Hobart Airspace Design Review

Final Report

March 2019

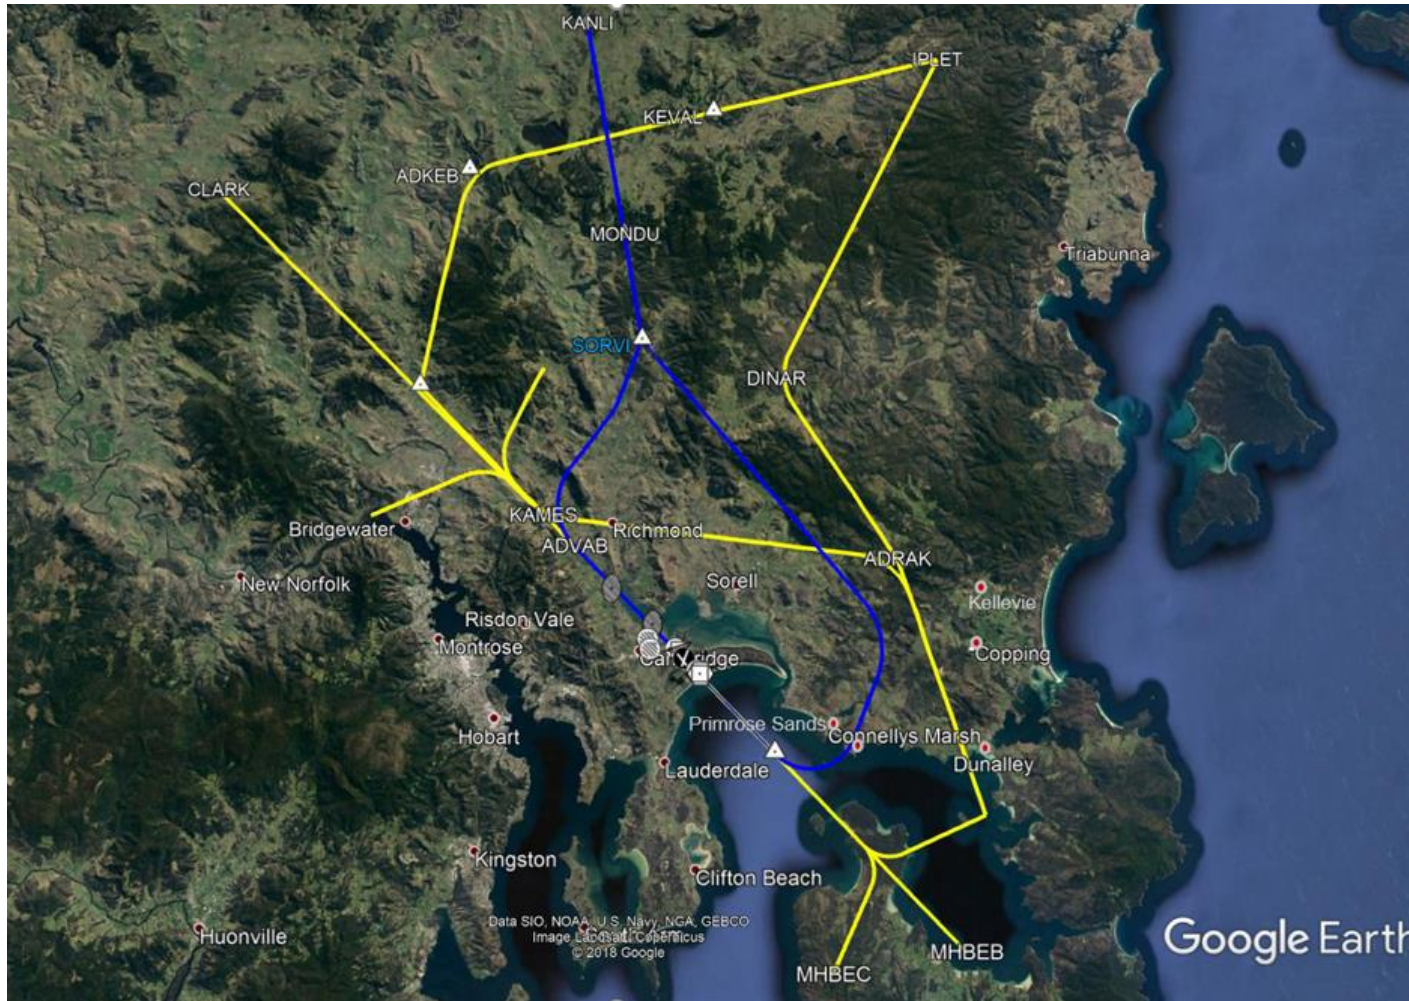
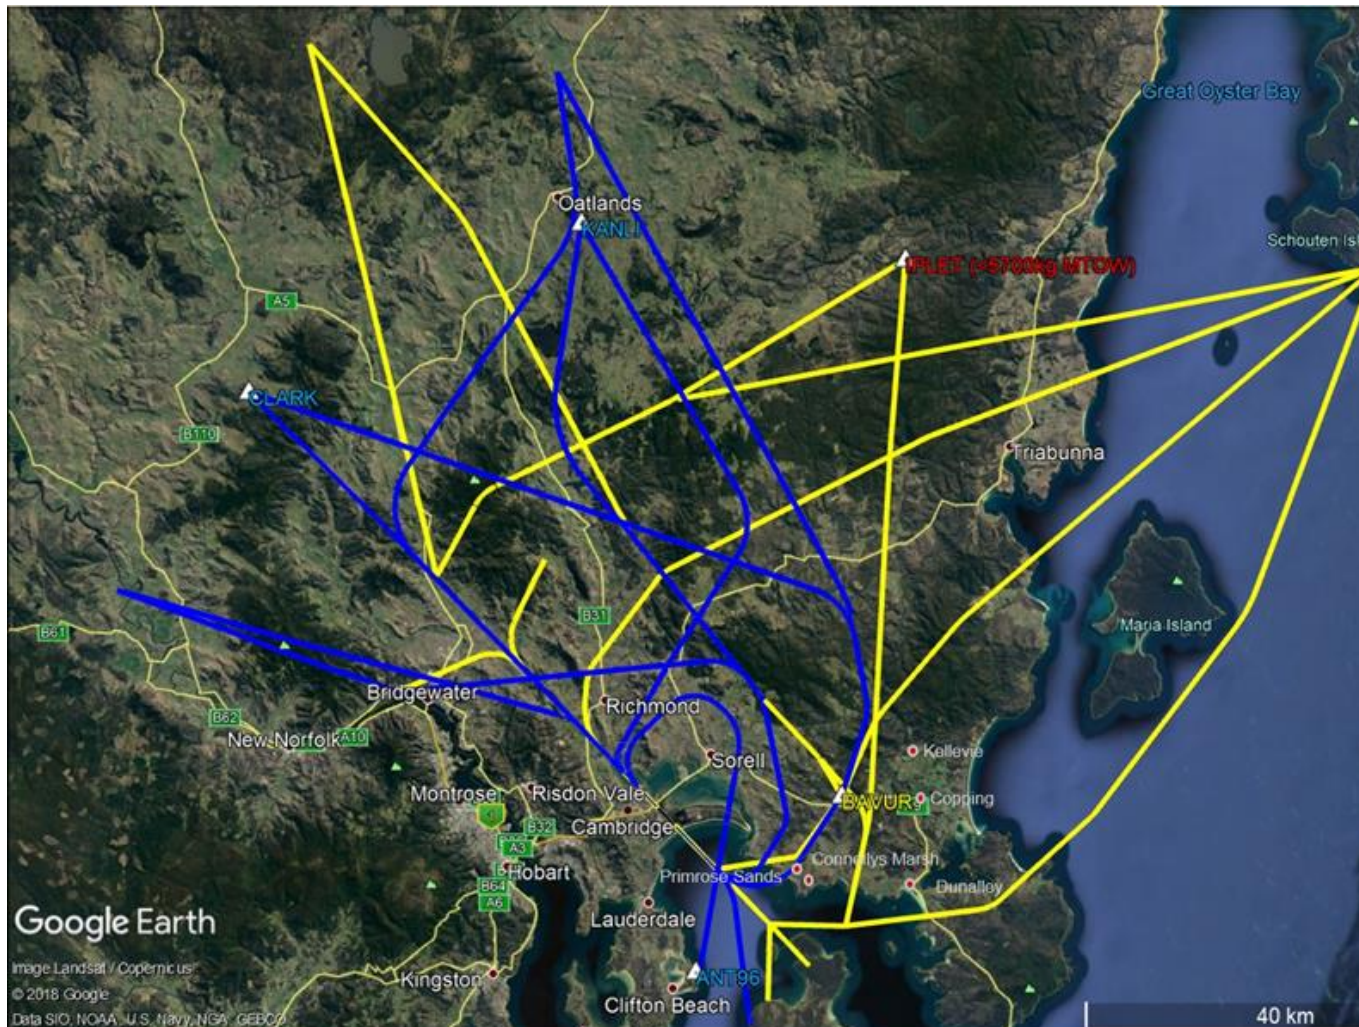
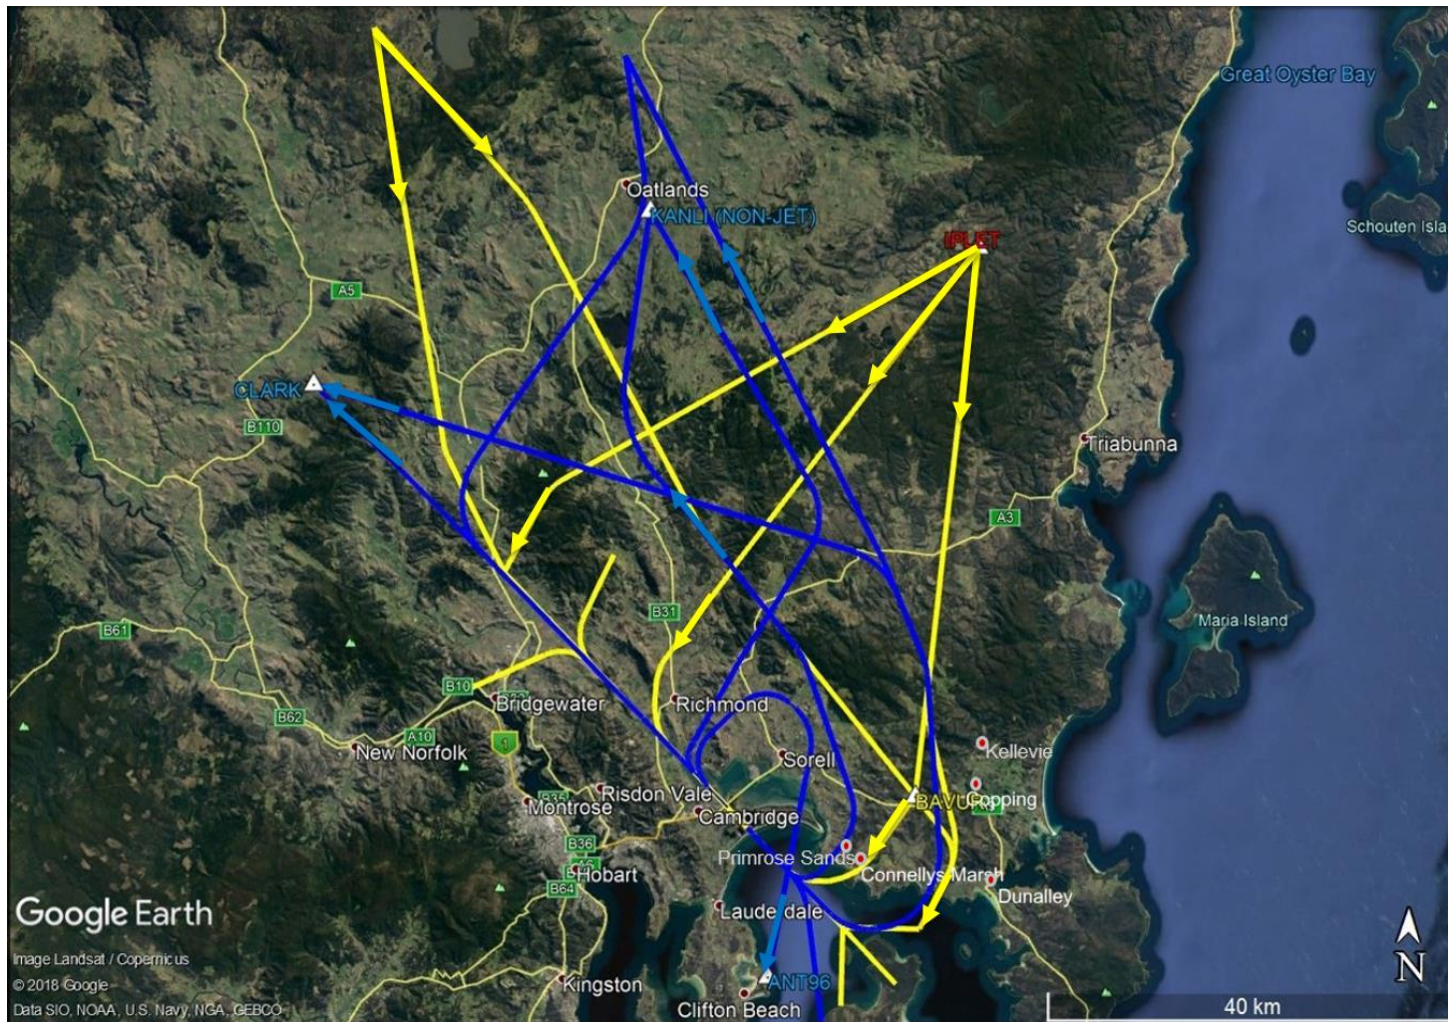
A comparison of the designs is provided in Figures 1, 2 and 3 in **Attachment 3**.

- The Runway 12 RNAV arrival flight path from the north, that was included in the proposed design, has been moved 3 kilometres (km) to the west of Kempton to avoid overflying communities of Kempton, Melton Mowbray, and Dysart.

- The Runway 12 RNAV arrival flight path from the east has been slightly adjusted to meet the needs of airline stakeholders. The community of Colebrook will experience arriving aircraft above 10,000 feet.

- The community of Nugent will experience increased overflight from the final Runway 30 arrival flight path design as a result of the removal of the proposed east coast over-the-water flight paths and the design of flight paths that track from IPLET waypoint to the Runway 30 approaches.

- Communities of Copping and Kelleve will experience arrivals on the Runway 30 STAR flight path that connects with the RNAV approach in the final design. This will be similar to the current arrival flights, but different from the proposed design. This is as a result of the removal of the proposed east coast over-the-water flight paths, and the design of flight paths that track from IPLET waypoint to join the Runway 30 approaches.

- In the final design, the community of Dunalley will experience arrivals on the Runway 30 STAR flight path, however this flight path will be 2 km to the west of the current design.

- Communities of Dunalley, Boomer Bay and Marion Bay will not experience arriving aircraft to the south in the final design, due to the removal of the proposed east coast over-the-water flight path that connected to the Runway 30 RNAV approach.

- Communities in the area of Murdunna, Sloping Main and Saltwater Creek will not experience arriving aircraft to the north in the final design, due to the removal of the proposed east coast over-the-water flight path that connected to the Runway 30 RNAV approach.

- Communities in Primrose Sands and Carlton will experience the Runway 30 Smart Tracking (RNP-AR) approach, however they will not experience the Runway 12 SID overflight in the final design.

- In the final design, the Runway 12 jet SID tracks between Connellys Marsh and Dunalley, however it tracks 4 km further over water than the proposed design, before turning over land. It is designed with a tracking point to contain the expected area of aircraft operations during the turn and will cross land at 6,000 feet, nearly 1000 feet higher than in the current or proposed designs.

- In the final design, the communities of Dodges Ferry, Forcett and Pawleena will experience non-jet aircraft operating on the Runway 12 non-jet SID, and this SID has been slightly tightened on the left turn near Forcett and Pawleena to enable the jet SID to be slightly amended to the west near Nugent.

- Communities in the area of Copping and Kelleve will experience the Runway 12 jet departures. However, as a result of the extension of the jet SID over water, most departing jet aircraft are expected to be higher than in the proposed design when flying near these communities (above 9,000 feet). Departing jet aircraft will be also be higher near Nugent than in the proposed design (above 10,000 feet).

The proposed east coast over-the-water flight paths have been removed.

Flights arriving from ports such as Sydney, Brisbane and Gold Coast will track via IPLET waypoint and then connect to the Runway 12 STARs and the Runway 30 STARs.

The Runway 30 STAR flight path was re-routed slightly, within the constraints of ensuring separation from the Runway 12 SID, so as to avoid directly overflying some communities.

- The Runway 12 non-jet SID has been adjusted slightly to tighten up the turn closer to the airport.
- The Runway 12 jet SID has been further extended over water before turning left to cross the coast between two communities.
- The jet SID flight path segment over land has been adjusted to turn slightly westward near Woodvine Nature Reserve.
